URBAN DESIGN CONSULTATION RESPONSE

Design Officer	Azhar Kapadi
Date	14.08.25 Review of amendments following earlier formal consultations
Application Reference	24/01120/FUL
Address	Lancashire Dog Training And Behaviour Centre , Bamford Road, Heywood, Rochdale, OL10 4TF
Proposal	Demolition of existing building and erection of three storey building comprising 6no. two bed apartments with associated car parking, boundary treatments, bin store and landscaping

PROPOSED FRONT ELEVATION

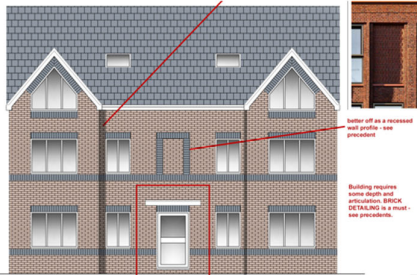
Concerns with front entrance have not been addressed. Poor entrance and welcome to building along main elevation.

Building requires some depth and articulation. BRICK DETAILING is a must - see precedents.

PROPOSED REAR ELEVATION

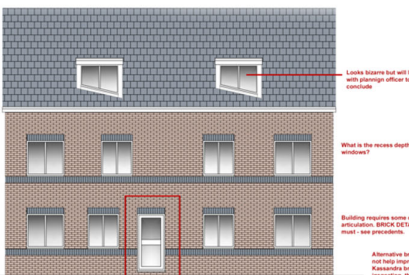
better off as a recessed and smaller - see precedent

Looks barren but will be with landscaping offset to console

What is the recess depth windows?

Building requires some articulation. BRICK DETAILING must - see precedents.

PROPOSED SIDE ELEVATION 1

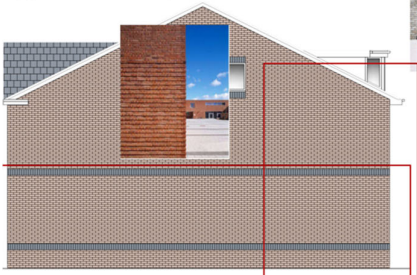
Alternative brick and half height windows to be done with it

PROPOSED SIDE ELEVATION 2

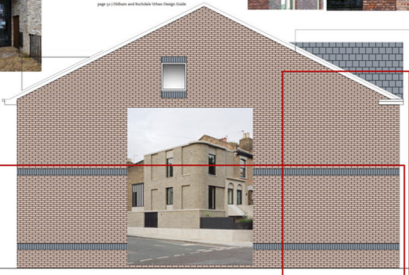
Do not present unattractive black elements in the street
